INNER WEST

DEVELOPMENT ASSESSMENT REPORT

Application No.	MOD/2021/0451
Address	17 Wharf Road BIRCHGROVE NSW 2041
Proposal	Modify approval for demolition of existing dwelling house, subdivision into two lots, construction of a new dwelling house and pool on each new lot, with remediation of both lots. Modifications include additional excavation, new dormer windows and additional floor area
Date of Lodgement	25 October 2021
Applicant	ESNH Design Pty Ltd
Owner	Mr Egidio J Gobbo Mrs Jillian T Gobbo
Number of Submissions	15
Value of works	\$1,914,000.00
Reason for determination at Planning Panel	Clause 4.6 variation exceeds 10% Number of submissions
Main Issues	Visual & Acoustic Privacy Streetscape
Recommendation	Approval with conditions
Attachment A	Recommended modified conditions of consent
Attachment B	Plans of proposed modified development
Attachment C	Statement of Heritage Significance
Attachment D	Structural and geotechnical report

Our assessment of the proposal is based on the following drawings by ESNH dated August 2021 and received by Heritage 21 on 23 August 2021. These are reproduced below for reference only; the full set of drawings accompanying the development application should be referred to for any details.

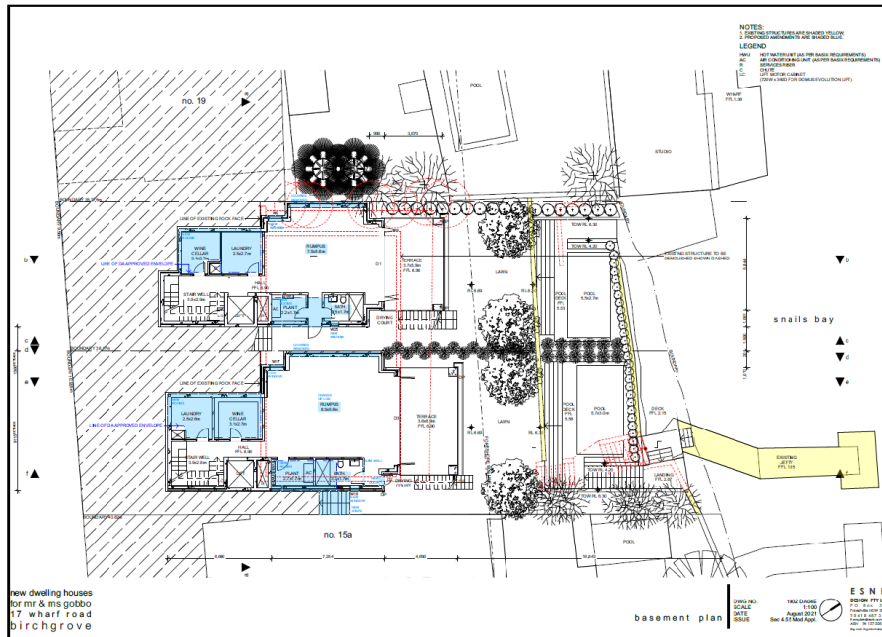
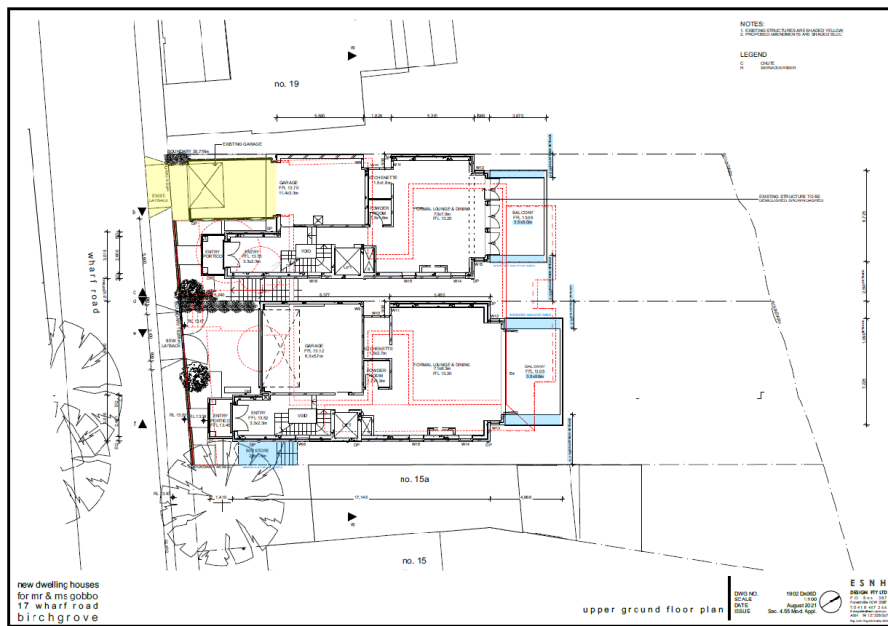
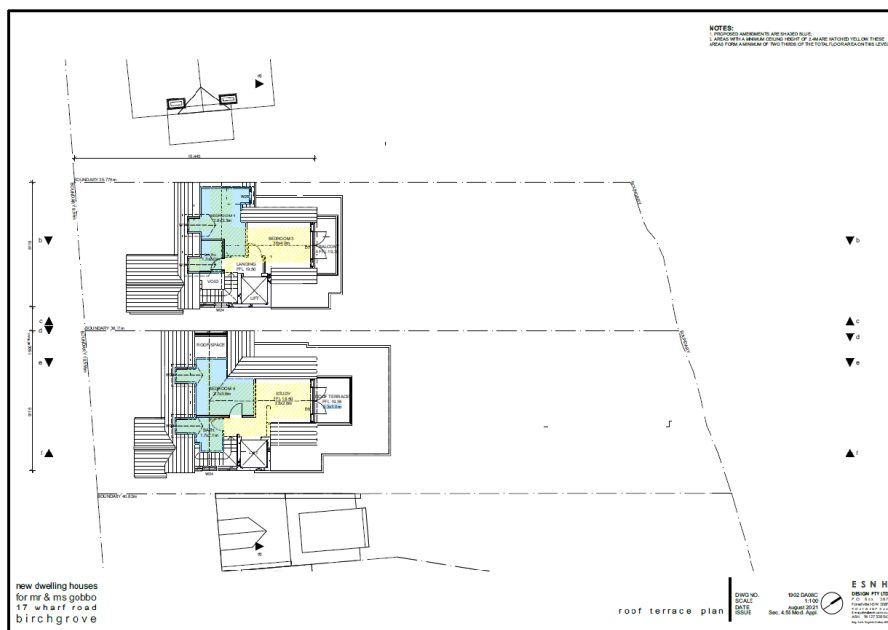
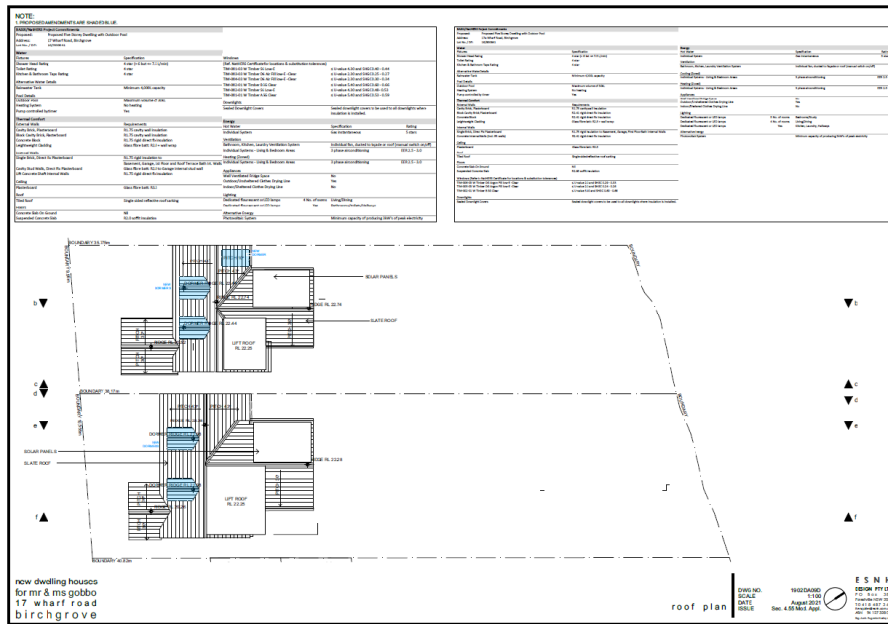
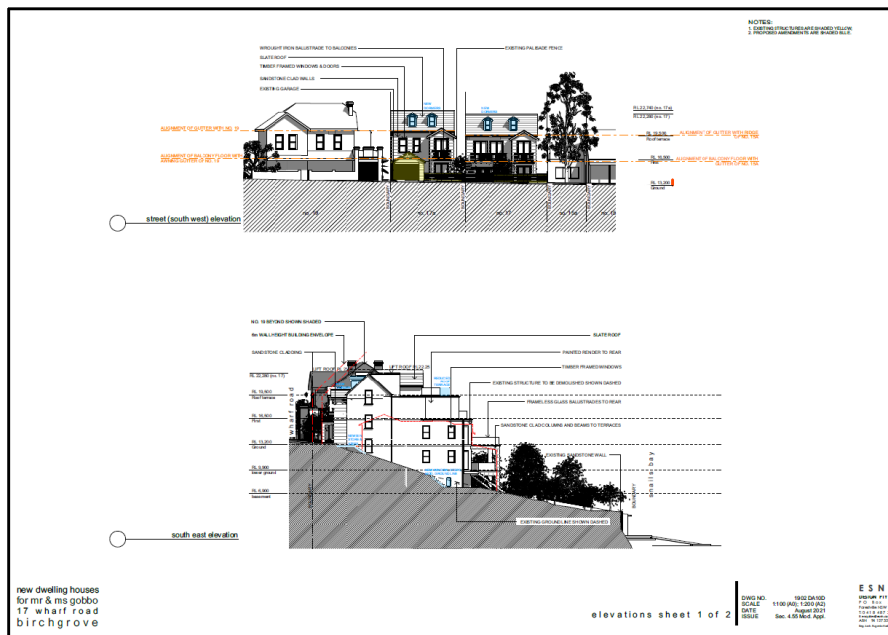
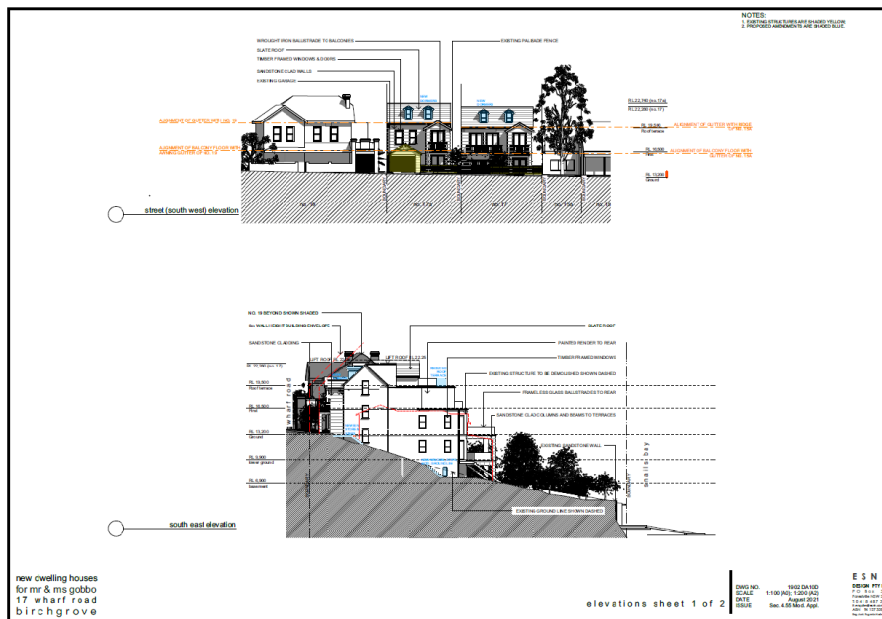
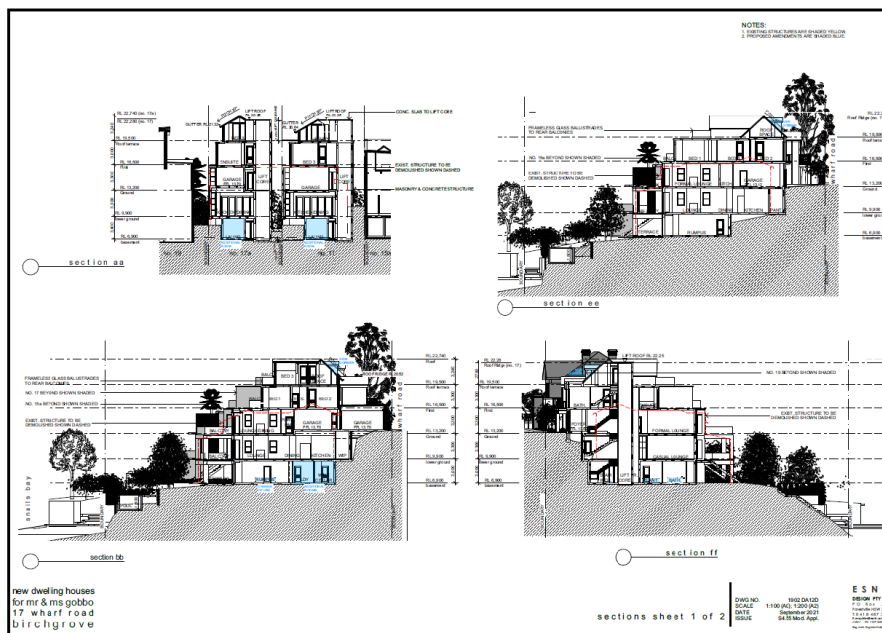
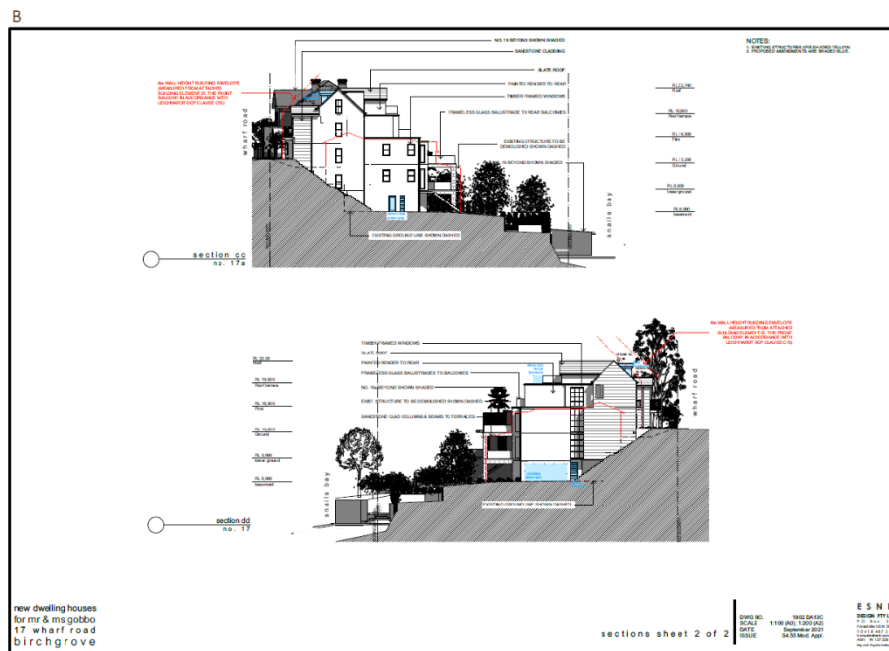
Assessment: The proposed dwellings would incorporate non-reflective glazed balustrades towards the rear. The proposed glazed balustrades are not an uncharacteristic feature within the Birchgrove and Ballast Point HCA as evident from the dwellings within the HCA immediately in the vicinity of the subject site at 15a Wharf Road, Birchgrove (refer to Figure 35); 13 Wharf Road, Birchgrove; the heritage listed dwellings at 19 Wharf Road, Birchgrove and at 19a Wharf Road, Birchgrove (refer to Figure 36). Therefore, the amount of glazing to solid ratio on the rear elevation would be sympathetic to the immediately surrounding development. Further, the non-reflective glazing would, in our opinion, ensure minimal disturbance to the established view lines to Snails Bay and Parramatta River, thus, these balustrades would not have any negative impact on the conservation values of the area. For the reasons outlined above, it is Heritage 21’s opinion that the proposal would be compatible with the significance and character of the Birchgrove and Ballast Point HCA.
